| Title          | <b>Comments on CDMA-based HO Ranging Procedure for IEEE 802.16m/D1 (15.2.5.10.5.1)</b>   |   |
| Re:            | IEEE 802.16 Working Group Letter Ballot #30: P802.16m/D1   |   |
| Abstract       | Comments on CDMA-based HO Ranging Procedure for IEEE P802.16m/D1 (15.2.5.10.5.1)   |   |

Figure 405-MS State machine during HO network re-entry

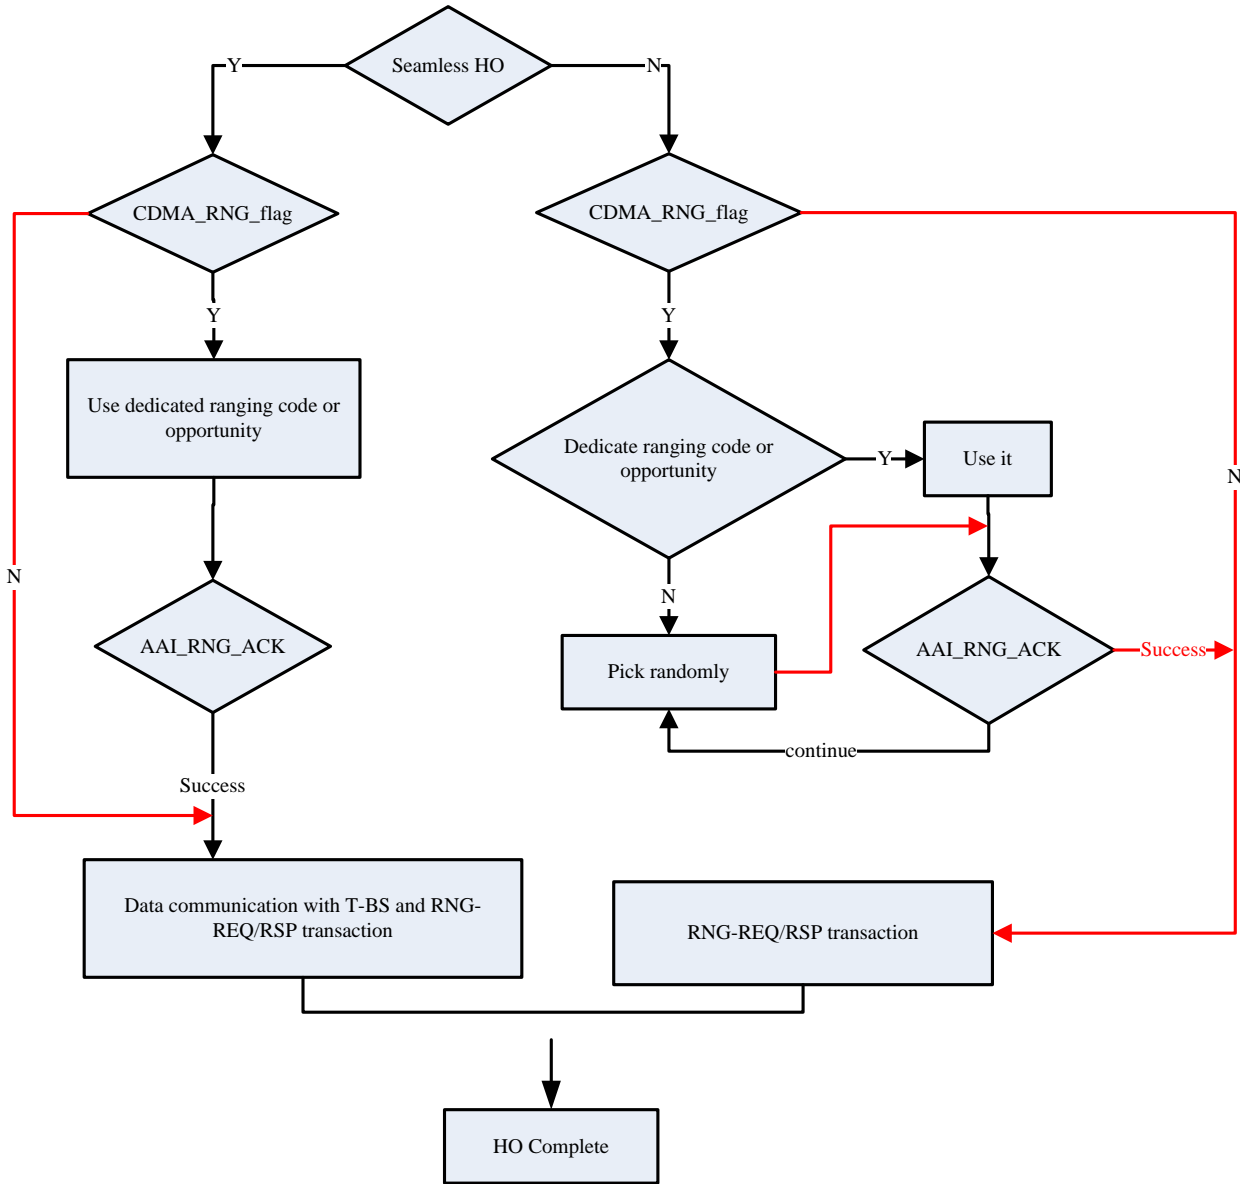
This contribution provides the corrected figure in the description of CDMA-based Ranging Procedure. It has some errors in Figure 405 in the description of ‘MS based state machine during HO network re-entry’.

*[In IEEE P80216m/D1, Section 15.2.5.10.5.1, replace Figure 405 by the following corrected figure]*
